Review of Nuclear Data Link  
Conceptual and Programmatic Framework

Research Support Branch  
Office of Nuclear Regulatory Research  
Nuclear Regulatory Commission

Energy Systems Department  
Research Triangle Institute  
Research Triangle Park, NC 27709

August 1980

Figure 2-2. Example NDH Hardware System (DEC Equipment)

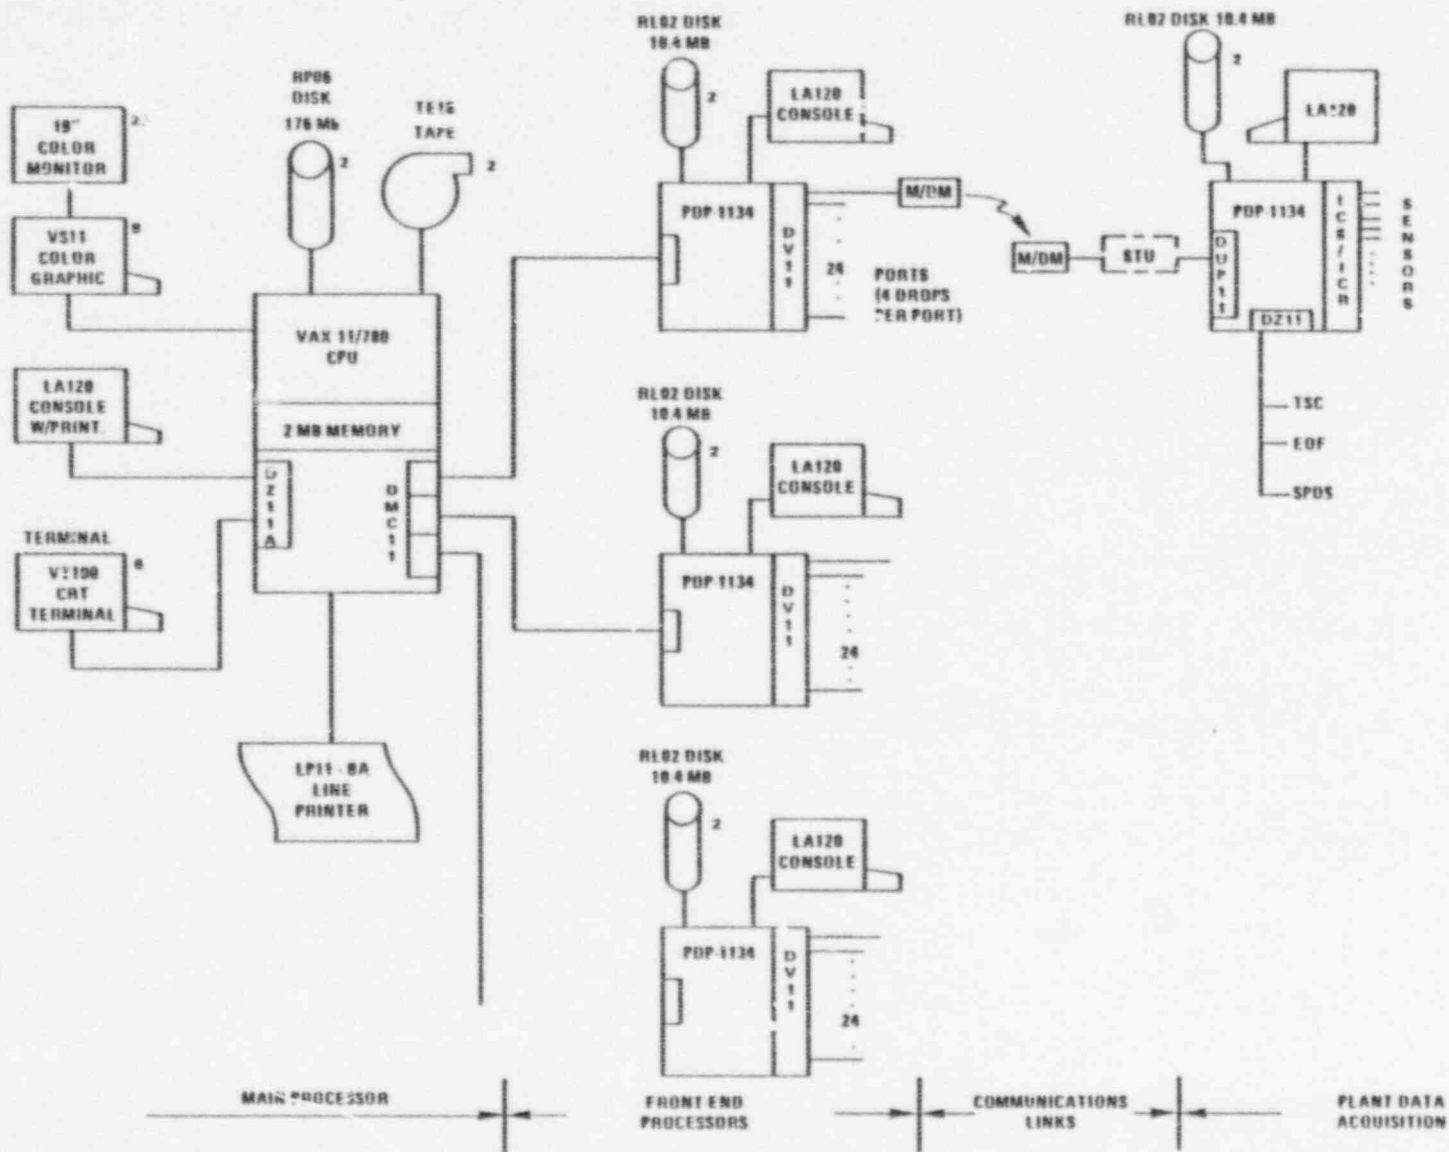
Data storage at the Operations Center for the required 30 minutes of data from each plant requires about 15 Mbytes with the previous assumptions of 200 reactors and 140 sensors per reactor. This is well within the disk capacity shown in Figure 2-2. The 2 weeks of data to be stored after an event for two plants (per the original specification) would require about 7.25 Mbytes. This is still well within the bulk storage capacity shown. The two RP06 disks provide redundancy in case of disk failure. Disks and other peripherals with moving mechanical elements are generally less reliable and subject to more maintenance than processors and other purely solid state elements. The TE16 tape drives can be used to archive data for long-term storage. Tapes are also useful as a software and data exchange medium with the software vendor and other computer centers.

Cost of the NDL Operations Center computer was estimated by RTI using the configuration of Figure 2-2. Cost figures are broken down in Table 2-2. The total cost of \$852,089 includes the front end processors and communications interface for up to 200 plants. Actually there is a maximum of 288 single plant interconnections possible, but it might be advisable to consider one PDP-1134 as a spare (or out of service for maintenance) so that 192 reactors could be accessed at one time. The hardware shown here assumes up to four drops (plant terminations) per hardware port at the Operations Center. This requires a communications protocol that is suitable to that arrangement and computer software to manage the communications. Such software is available, DECNET being the one for the hardware configuration shown.

Figure 2-3. Communications Topology Example

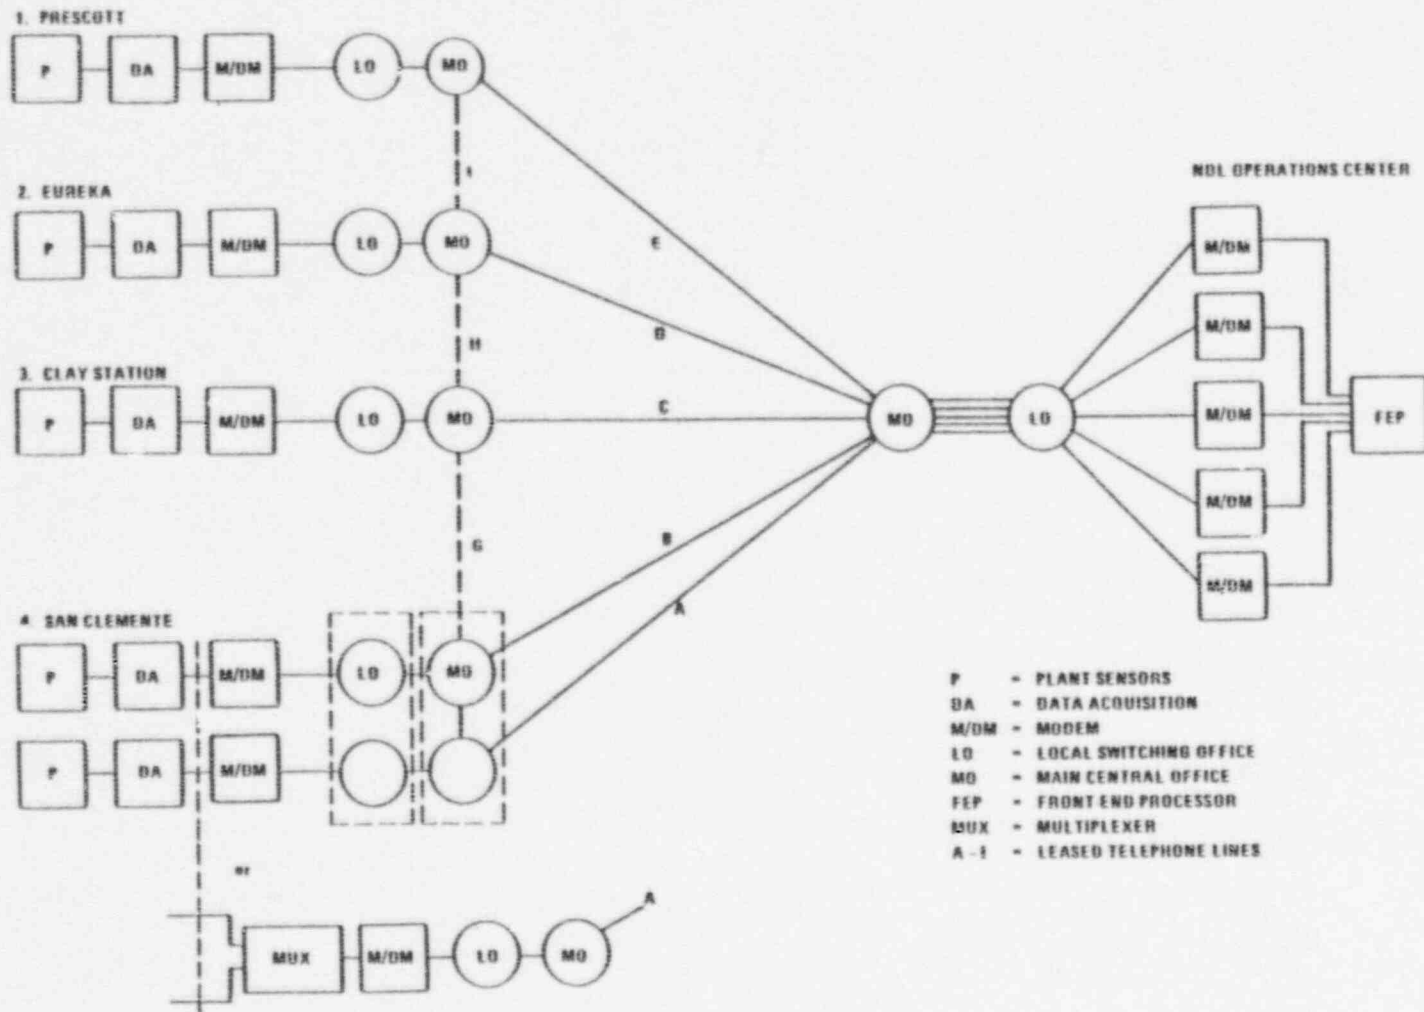
elements between the plant, P, and the Operations Center, FEP. There is actually only one main office (MO) and local office (LO) serving the San Clemente site, and so it is possible to eliminate the long-line B by multiplexing the two reactors onto one line. Saving the line cost in this manner means that if the multiplexor or modem fails, two plants rather than one are unavailable. A second network possibility is the multidrop in which the lines A, G, H, and I are used and considered a single long-line for costing purposes. Each reactor site is then a "drop" off the line and so is the Operations Center end of the line. This can save cost on leased line charges as shown below. Finally, the line E can be added to the A, G, H, I line to form a ring network.

The ring network provides two paths to any site by connecting through either line A or line E. Thus, if line G is disabled, sites 1, 2 and 3 communicate through E, I, H and site 4 through A. The line cost savings is only \$2,509/mo. but this has a present worth of over \$202,000. The ring network might also employ the dial-up back-up, though less reliability gain is provided.
